2012 Geotechnical Annual Review, Minto Mine, YT

MINTO EXPLORATIONS LTD.

SRK Consulting (Canada) Inc.

November 2012

1 Dry Stack Tailings Facility – Surface Diversion Berm – Western Portion

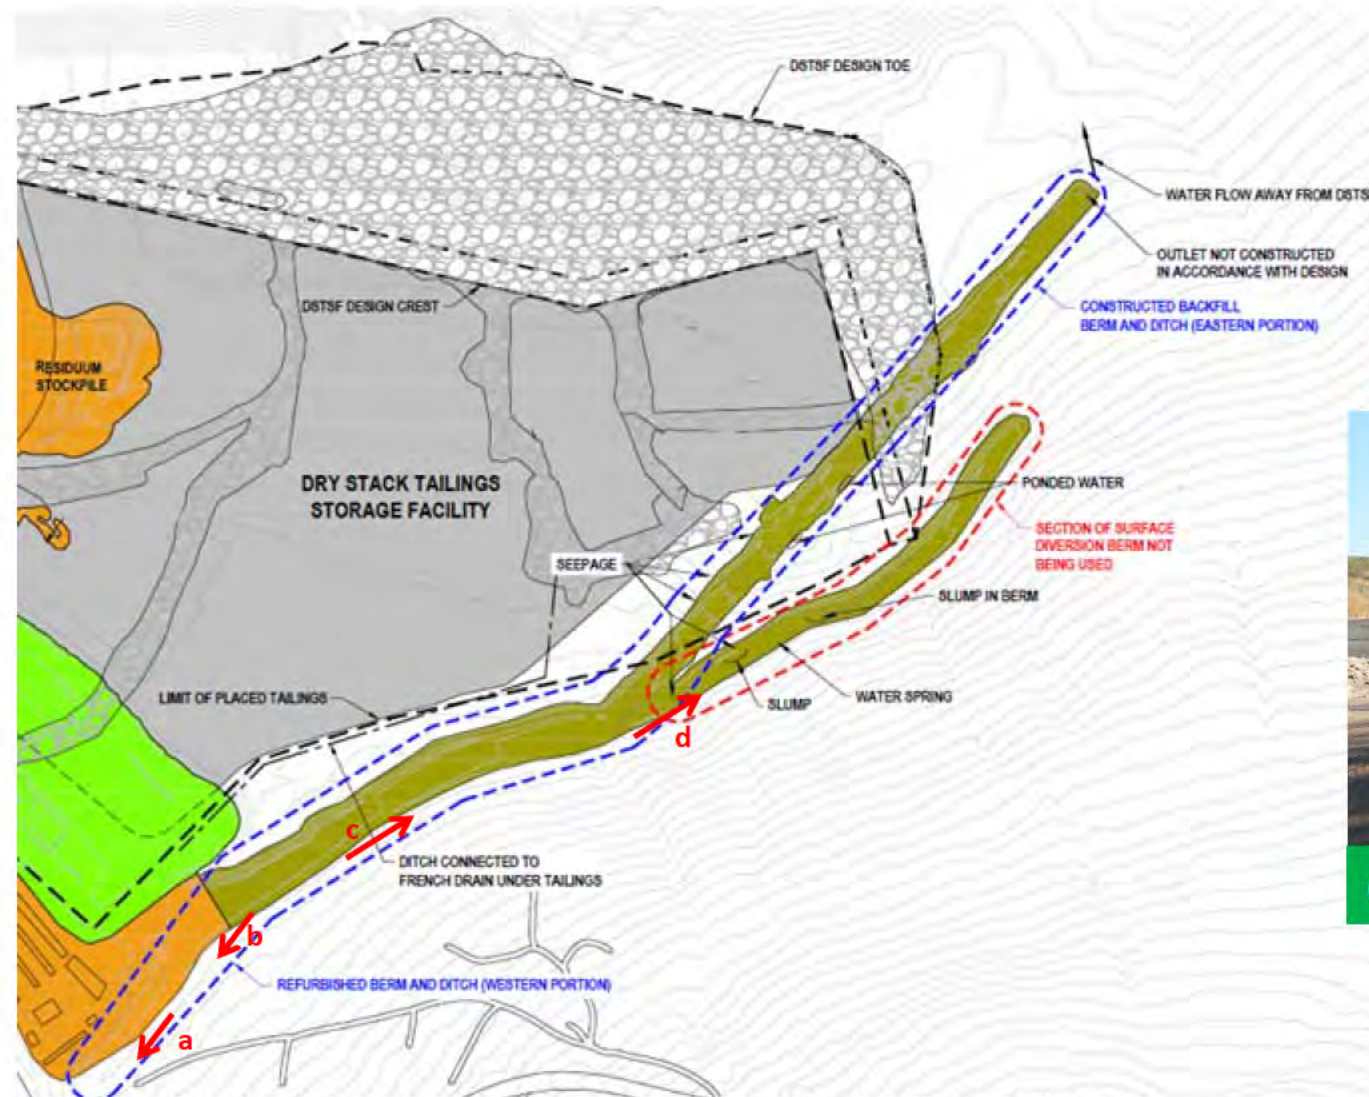
- In general, the western portion of the berm and ditch was functional at the time of inspection, with conditions deteriorating towards the east. East of the location of Photo (d), the ditch is in very poor condition. Details on the eastern portion of the ditch are provided in Figure 5.
- Two seeps were observed below the berm near the locations noted in the 2011 inspection and on the plan in this figure.

- (a) A ditch block at the upstream portion of the ditch has been removed. Layers of geotextile and liner remain across the channel, a small amount of water remains ponded upstream of the block. A small waste rock stockpile is present to the right of the photo.

- (b) Tension cracks are present on the berm side of the ditch over a significant length of the ditch.
- (c) Looking downstream in the western portion of the ditch. Tension cracks visible along the road. The geosynthetic liner is exposed at all points downstream of this location.

- (d) View of the ditch looking downstream at the point where the ditch crosses the south wing portion of the diversion system (outlined in red in the figure plan).

- The ditch near this location and further downstream is not well formed, with sediments building up in the channel, and the liner sagging down the channel sides.

- Liner sections are over-lapped, but not welded. Gaps are present between some sections allowing water to pass through.
- Water was also observed to flow over the sides of the liner in places.

1 Dry Stack Tailings Facility – Surface Diversion Berm – Eastern Portion

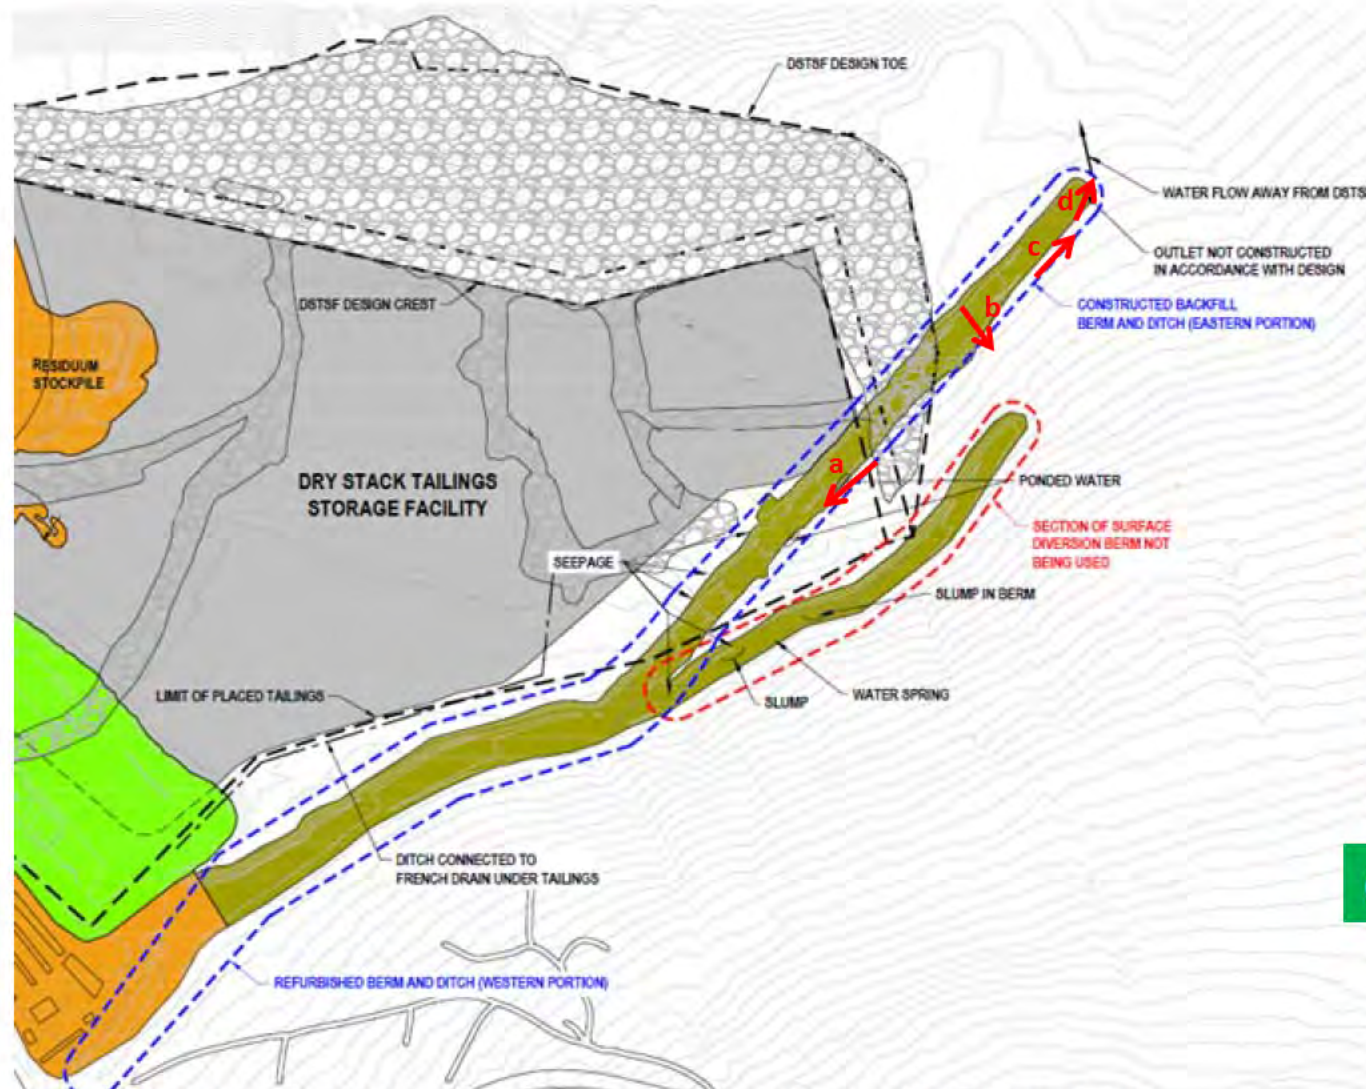
The eastern portion of the ditch is in poor condition. At the time of the inspection, it is estimated that approximately half of the flow was lost along the east portion of the ditch.

- the channel appears undersized (Photo (b) and (c));
- The channel bed has settled in some areas resulting in ponding water (Photo (a));
- the liner has torn in many locations (Photo (c)),
- The anchoring of the liner has failed resulting in the liner slumping down the sides of the channel (Photo (b)),
- There are gaps in the liner resulting in water flowing beneath the liner and over the sides of the liner (Photo (a)).
- As noted in the 2011 inspection, the discharge point of the ditch (Photo (d)) was also not constructed in accordance with the March 23, 2010 Issued for Use Drawing TDD-01, where flow should discharge into a lined stilling basin.
- The vegetation surrounding the discharge point is stressed with many leaning dead trees in the area.

- The surface diversion berm should be rehabilitated to capture and convey water along the entire length of the ditch.
- The ditch discharge should be constructed to an engineered design.

3 Southwest Waste Dump

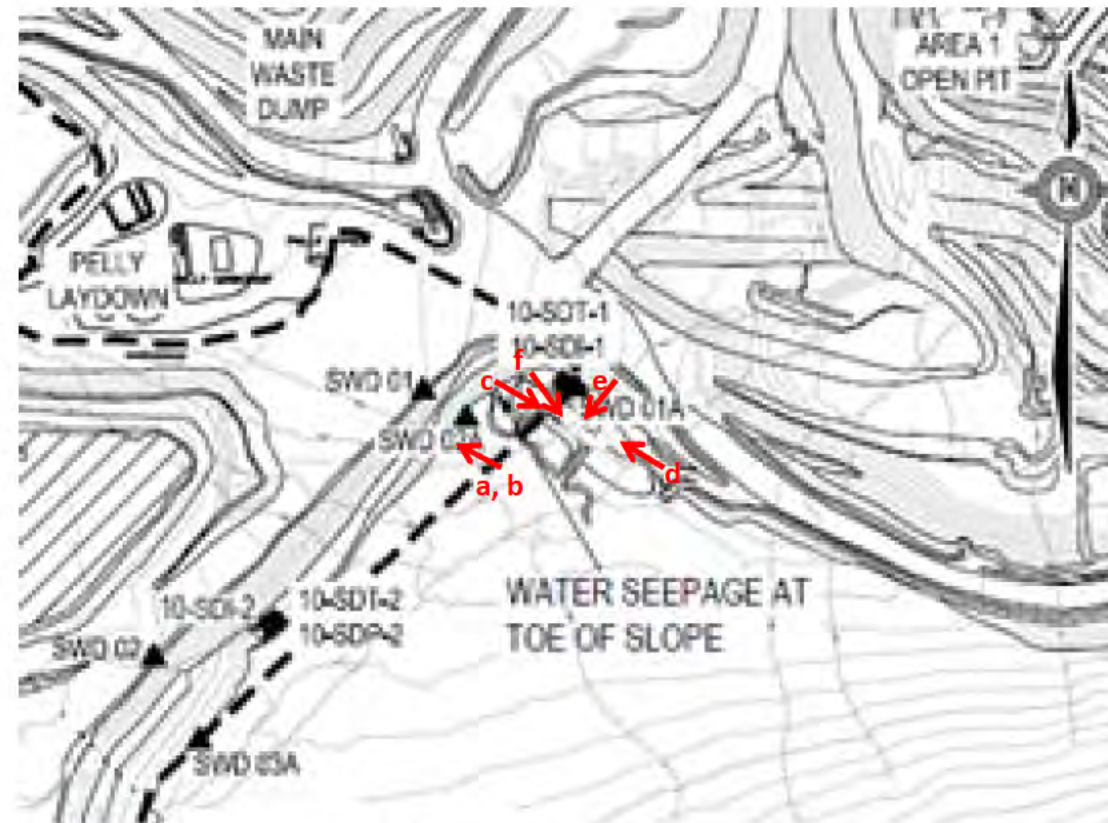
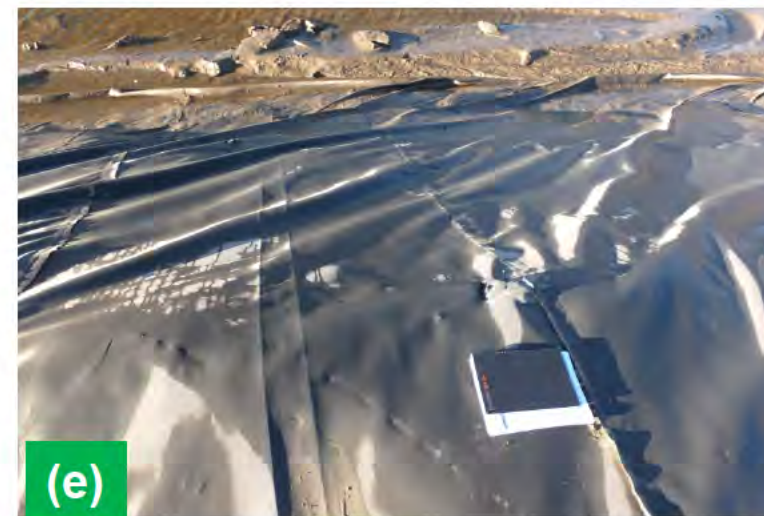
Photos (a) and (b) show the outlet of the culvert at the NE corner of the dump and east of the Pelly Laydown area.

- No photos of the area from previous inspections are available and as a result, it is unclear if erosion beneath the culvert outlet is continuing or has stabilized.
- Based on equipment tracks in the area, it appears that the large diameter boulders have been placed along the slope to mitigate erosion. The area should be monitored at least annually with a photographic record maintained to observed for changes.

Photos (c) to (f) show the W-15 Detention Structure Area.

- Water continues to seep from the toe of the fill slope into the W-15 Detention Structure Area. The water was clear, with low turbidity.
- Sediment is accumulating at the west end of the pond. The weight of the sediment appears to have stretched the liner and resulted in a large tear from along the crest of the berm at the anchorage point.
- There are 3 punctures in the liner located near the crest west of the pump (Punctures shown in photo (e)). The punctures were caused by either equipment damage or rocks raveling down the slope.
- Photo (d): The inlet line for the pump is placed on a layer of rip-rap placed directly on the liner. A large boulder is in the foreground of the photo directly on the liner.

- Continue monitoring for erosion at the culvert outlet and maintain a photographic record to inspect for changes in condition.
- The anchor system of the liner on the west side of the facility should be repaired the next time a liner crew is on site. At the same opportunity the holes in the liner should be repaired.
- Placement of a safety berm or snow fencing should be considered to prevent further damage to the liner from equipment trafficking and/or rocks.

4 Reclamation Overburden Dump

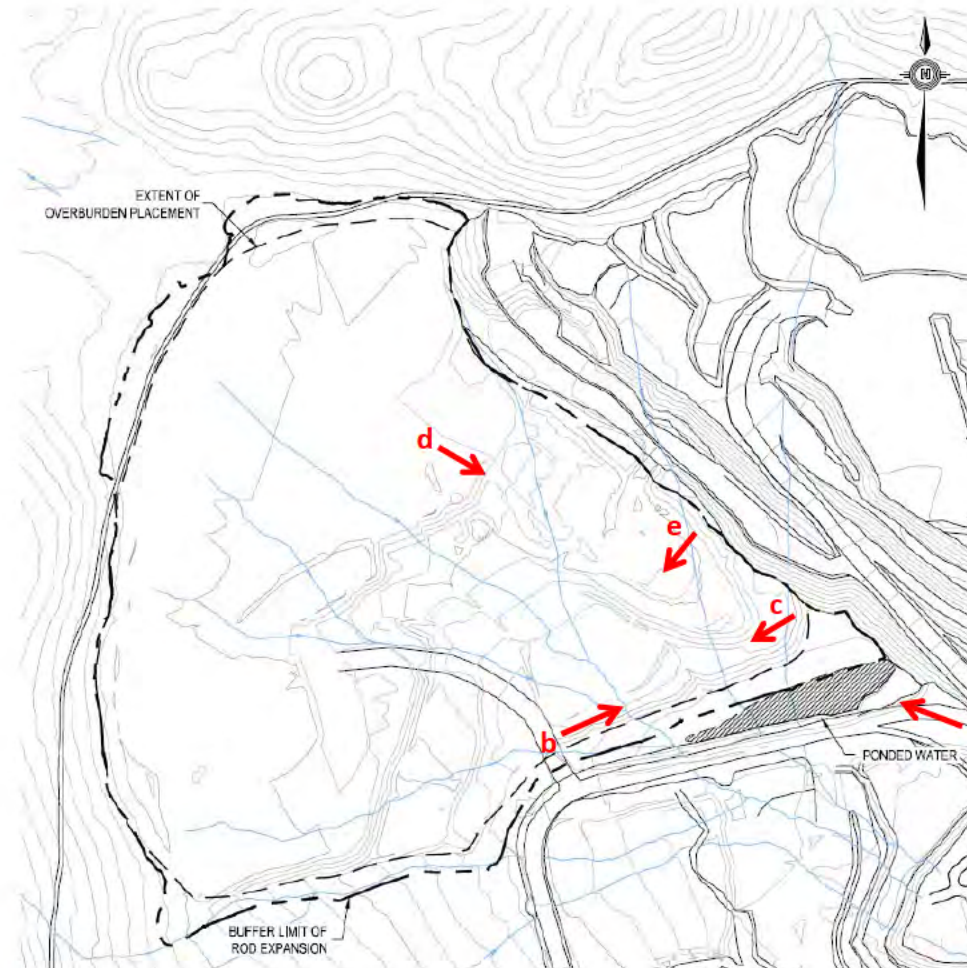
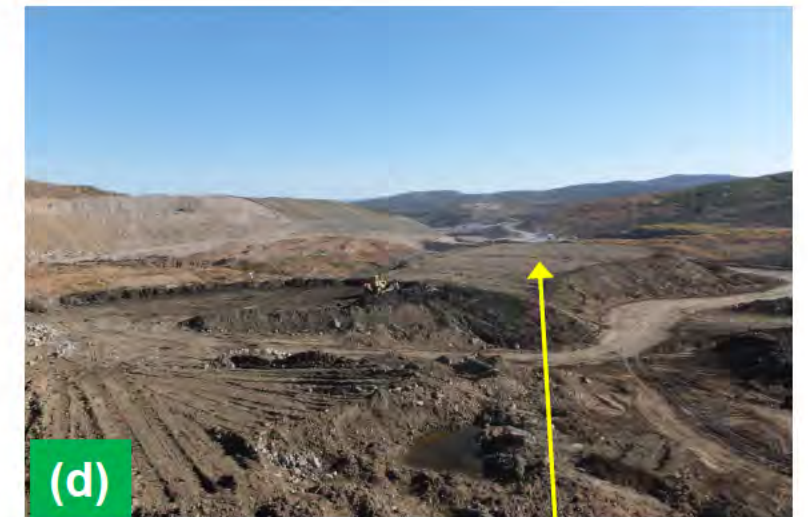
• Conditions of the dump are similar to conditions reported in the 2011 site inspection completed by EBA. Slumping, settlement and tension cracks are expected in the dump as it is constructed with frozen overburden with thawing expected.

- a) Ponded water adjacent to the Dyno Access Road southeast of the ROD. Two small erosional channels were observed (circled in yellow).
- b) Localized slumping of the perimeter slope. The 2011 inspection notes that some of the sloughing areas have increased in size.
- c) Discontinuous tension cracks and differential settlement observed along the perimeter crest (above the slope shown in Photo (b)).
- d) Overview of the ROD dump area.
- e) Tension cracks and zones of differential settlement present throughout the lift whose location is shown in Photo (d) and the figure below. The ground is undulating by approximately 0.3 m.

Recommendations are the same as those mentioned in the 2011 EBA annual review:

- Installation of a rip-rap channel down the slope to minimize slope erosion. Areas near the exiting erosion channels should be regraded to direct runoff to the rip-rap channel.
- Monitoring of the ponded water to ensure that the offset from the dump toe is maintained as stipulated in the design report.
- The toe of the dump should be surveyed annually to confirm it is within the permitted boundary.

7 Mill and Camp Site

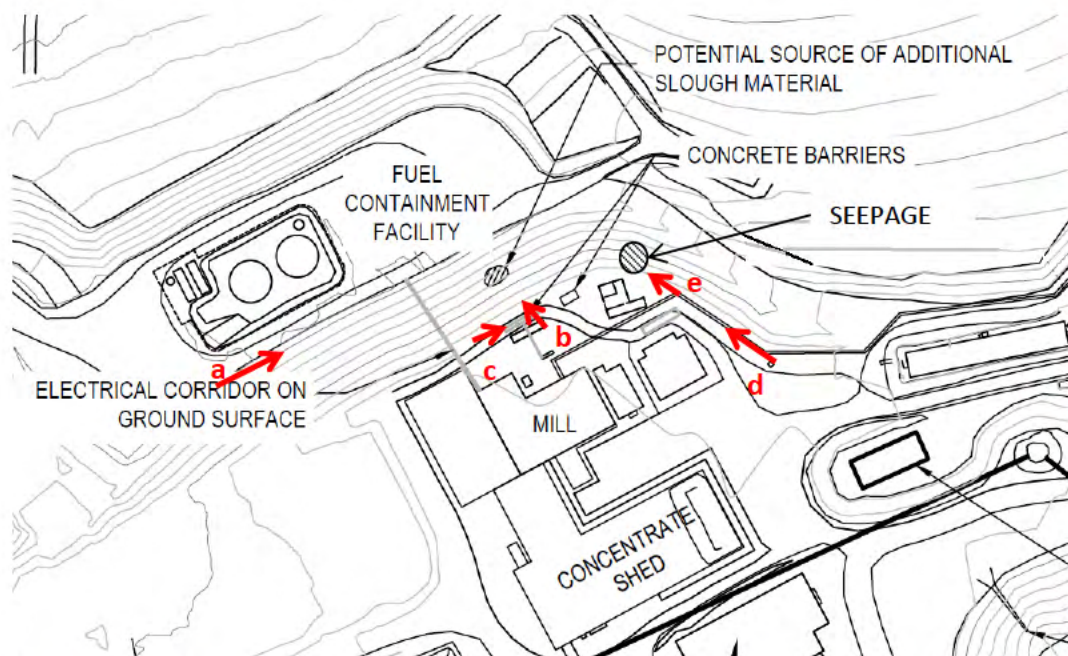
- a) Slope above the main mill site appears stable
 - Safety berms at the top of the slope are in good condition.
 - Eroded sand/gravel is generally present at the base of the slope with occasional cobbles/boulders up to 300 mm.
- b) A small slough is present near the center of the slope approximately 10 m east of the electrical corridor where there appears to be some larger rocks that have raveled down the slope.
- c) Concrete barriers are present at the toe below this area. The barrier is approaching the capacity for containment.
- d) East end of the mill slope looking northwest. Two small seeps (circled and shown in 'e') are present at the corner of the slope, emerging approximately 2 m above the toe.
- e) View of the seep location. The flow is a minor trickle, with algae present along the stream path.

- It is recommended that the concrete barrier (Photo (c)) be cleaned out or raised to capture any additional sloughing material. A simple solution to raise the barrier may be to place wooden planks anchored by rebar.

7 Mill and Camp Site

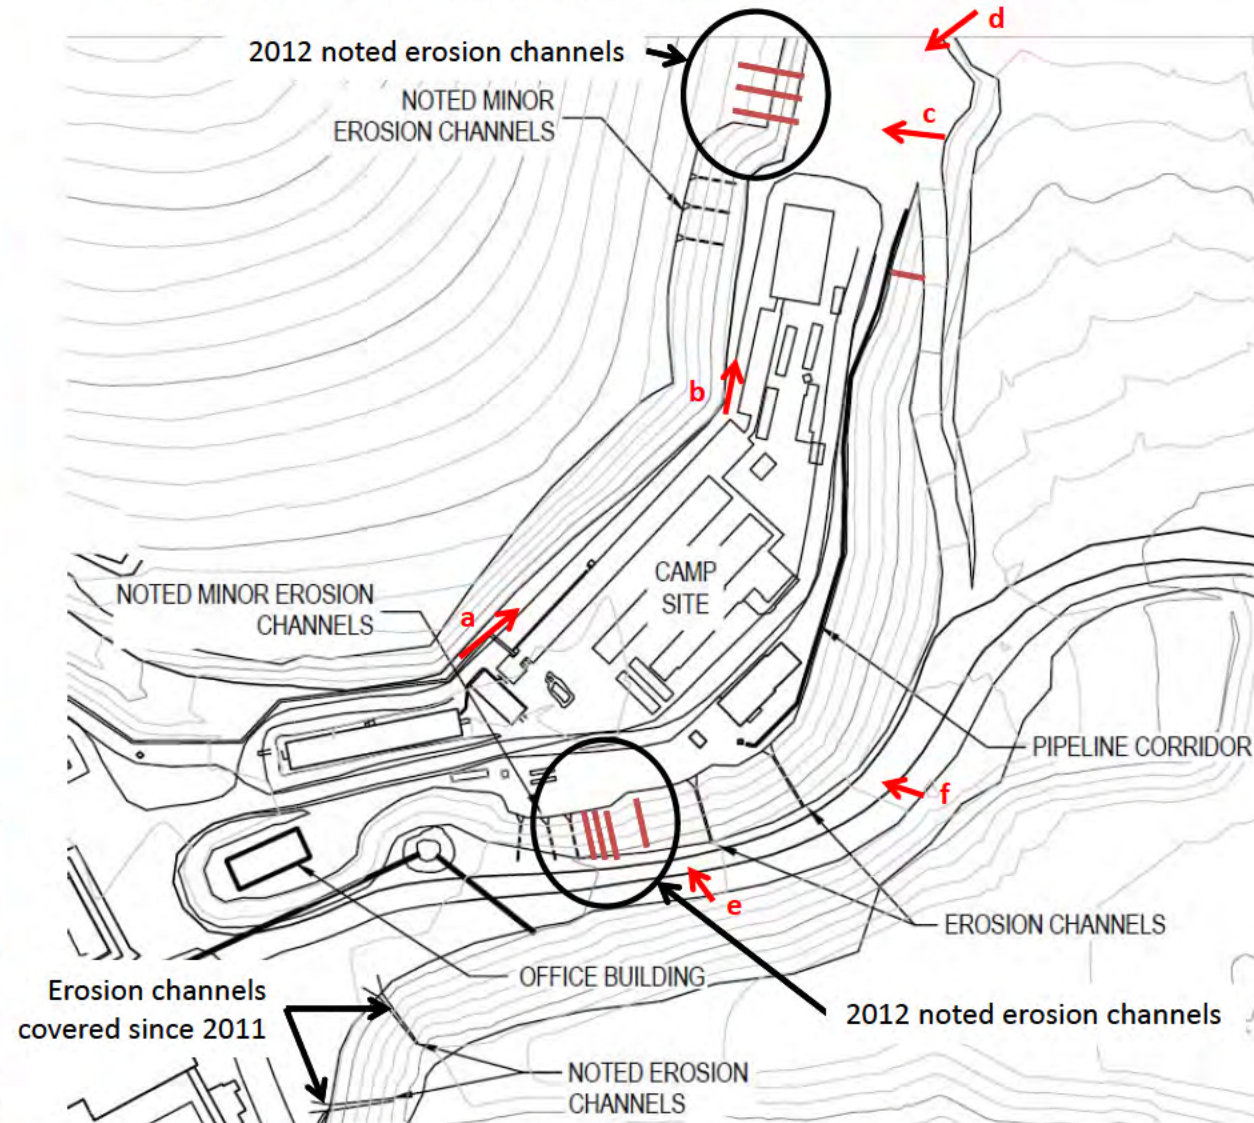
- a) & b) Slope above the main camp site appears stable.
 - Eroded sand/gravel is generally present at the base of the slope with occasional cobbles/boulders up to 300 mm.
- c) Minor erosion channels present at the north end of the camp area. Three minor erosion channels were noted in the EBA 2011 in this area. There are numerous other minor erosion channels in this area, as can be seen in photos (c) and (d). It is unclear if these channels were present in 2011.
- d) & e) Erosion channels present south of the camp site pad. It appears that the same erosion channels noted in the 2011 inspection are still present as well as additional erosion channels, as noted in the figure below.

Note: Since the 2011 inspection, fill was placed below the main access road as part of the Mill Valley Fill pad that have covered over the erosion channels noted in the figure below.

- The 2011 EBA annual review recommended the area above the erosion channels below the camp pad be regraded to promote runoff away from these areas and that one of the channels be filled with rip-rap or a "half culvert to provide a path for the water to drain". It appears that no action has been taken in the past year and that further erosion channels have developed.
- It is recommended that these actions be completed in the following year. In place of the surface grading, a small ditch could be constructed near the slope crest to direct runoff to the drop channel or half-culvert.
